ADDENDUM NO. 01

PROJECT NAME: MORRILL ROOF REPLACEMENT
UNL PROJECT NUMBER: C022P182

DATE OF ISSUANCE: OCTOBER 29, 2012
DATE OF BID OPENING: NOVEMBER 8, 2012

A2.6
 REVISED

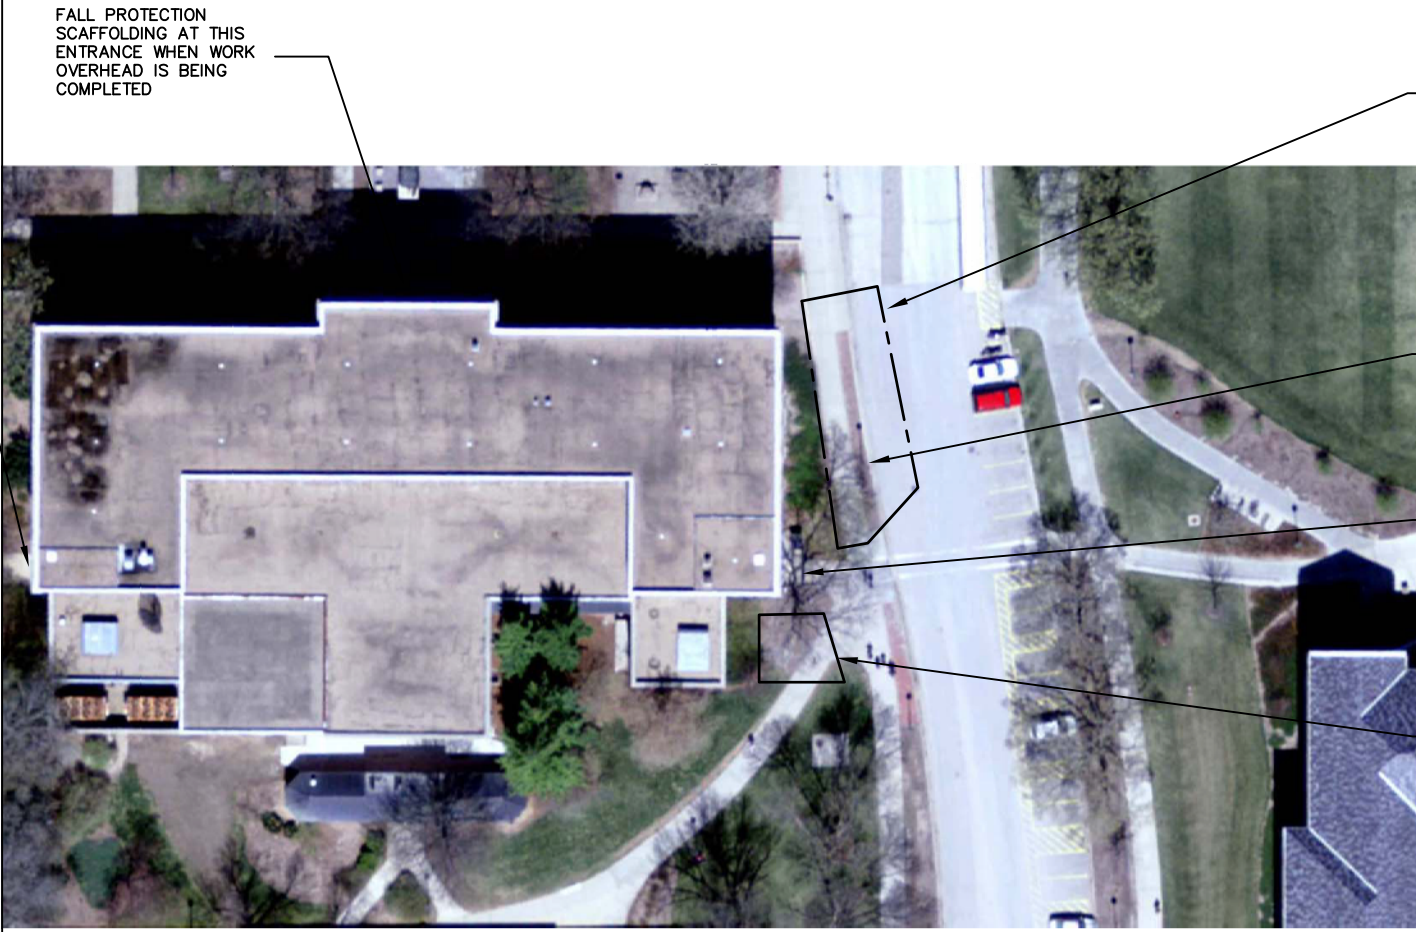
ITEM #6 Refer to the Project Manual, Appendix "A", Drawing Sheet A2.6, and to the attached Drawing Sheet A2.6 Revised, dated October 26, 2012.

- A. Replace detail sheet A2.6 – Section at Satellite – Roof "A", with the attached revised detail sheet A2.6 Revised, dated October 26, 2012, showing the flashing condition similar to Firestone detail "P-3".

STAGING PLAN

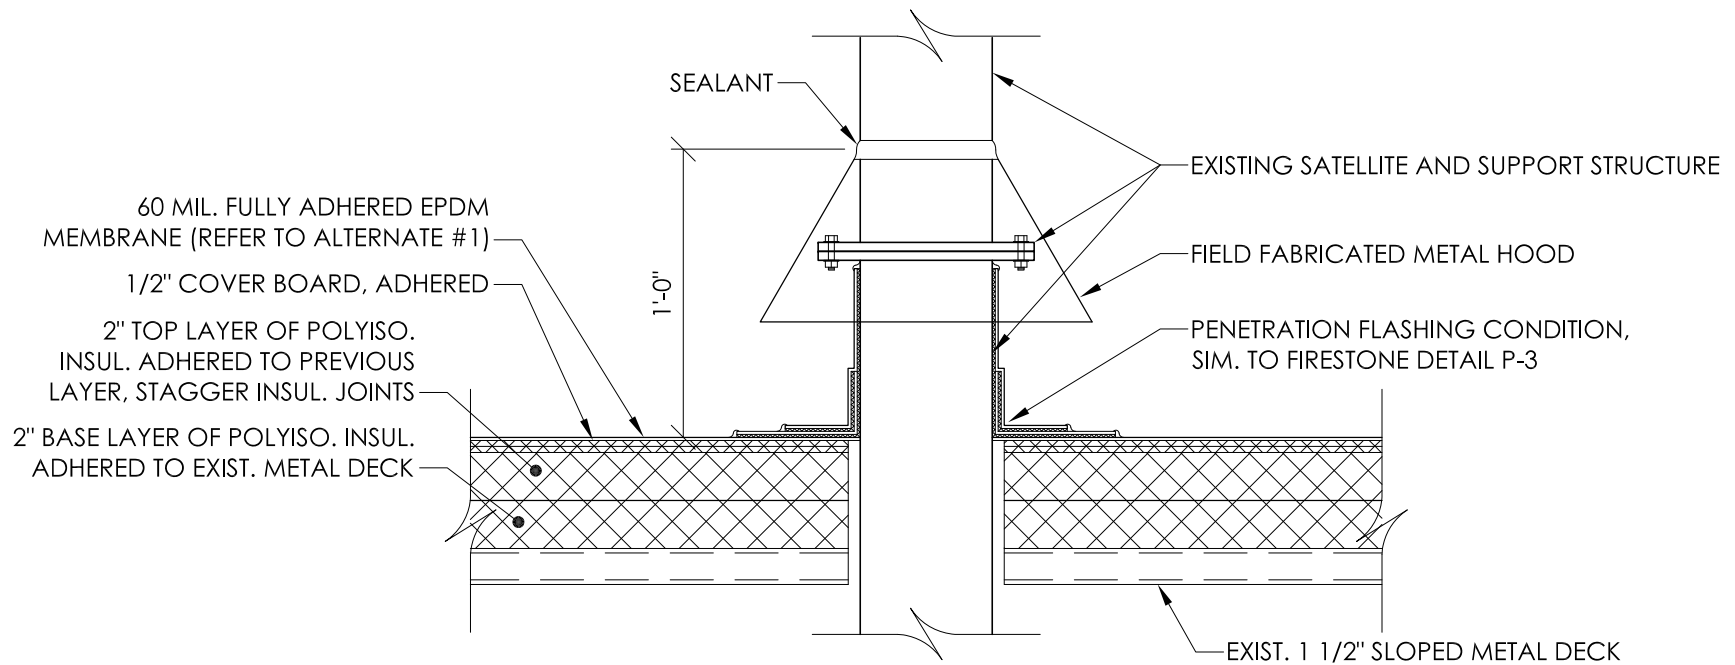
ITEM #2 Refer to the Project Manual, Appendix "A", Drawing Sheet C1.2 and to the attached revised Staging Area Plan, dated October 26, 2012.

- A. The staging area footprint will be revised in accordance with the attached Staging Area Plan, dated October 26, 2012.

6'-0" TALL CHAIN LINK FENCE WITH RED CANVAS SCREENING, EAST SIDE OF FENCE TO BE 18'-0" FROM WEST SIDE OF PARKING STALLS. EXACT LOCATION TO BE COORDINATED WITH UNL PROJECT MANAGER.

STAGING AREA, CLOSE PORTION OF SIDEWALK AND STREET AS SHOWN

FALL PROTECTION SCAFFOLDING AT THIS ENTRANCE AT ALL TIMES, DUMPSTER MUST REMAIN ACCESSIBLE FROM STREET

DUMPSTER LOCATION. 6' CHAIN LINK FENCE WITH RED CANVAS REQUIRED. EXACT LOCATION TO BE COORDINATED WITH UNL PROJECT MANAGER.
